Access Compliance Report

Public Rights-of-Way

(Curb Ramps)

Intersection ID: 26538	Main Street: FONTAINE_CT	Cross Street: TARLETON_TWINS_TR	Location: SE
ADA ID: 68F28BAD04FC	Ramp Type: Perp	Initial Pass/Fail: Fail	Overall Compliance: No
Severity Score: 47.5			
Codes/Mitigation Info/Possible Solution		Field Measurements/Component Compliance

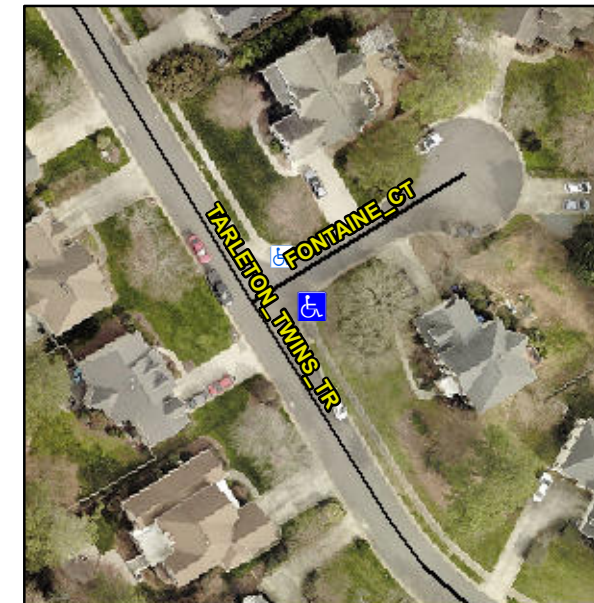
Not Found, R304.5.1, R304.5.3

Compliance	Description	Data	Compliance	Description	Data
N/A	Ramp Length (in)	96.0	Yes	Ramp Slope (%)	7.5
No	Ramp Width (in)	24.0	No	Ramp XSlope (%)	5.4
N/A	Flare Type LT	N/A	N/A	Flare Type RT	N/A
N/A	Flare Slope LT (%)	N/A	N/A	Flare Slope RT (%)	N/A
N/A	Flare Traversable LT?	N/A	N/A	Flare Traversable RT?	N/A
N/A	Landing Length (in)	N/A	N/A	DWS Provided?	N/A
N/A	Landing Width (in)	N/A	N/A	DWS Contrast?	N/A
N/A	Landing Slope (%)	N/A	N/A	DWS Length (in)	N/A
N/A	Landing X Slope (%)	N/A	N/A	DWS Full Width?	N/A
N/A	Landing Curb? (Y/N)	N/A	N/A	DWS Offset (in)	N/A
N/A	Shared Landing?	N/A			
N/A	Gutter Ponding?	N/A	N/A	Gutter Slope (%)	N/A
N/A	Gutter Lip Ht (in)	N/A	N/A	Gutter X Slope (%)	N/A
N/A	Painted X Walk1?	No	N/A	Painted X Walk2?	N/A
	X Walk 1 Direction	To N		X Walk 2 Direction	N/A
N/A	X Walk 1 Width (in)	N/A	N/A	X Walk 2 Width (in)	N/A
	X Walk 1 Slope (%)	2.8		X Walk 2 Slope (%)	N/A
	X Walk 1 X Slope (%)	1.3		X Walk 2 X Slope (%)	N/A

Remove & Replace Entire Ramp.
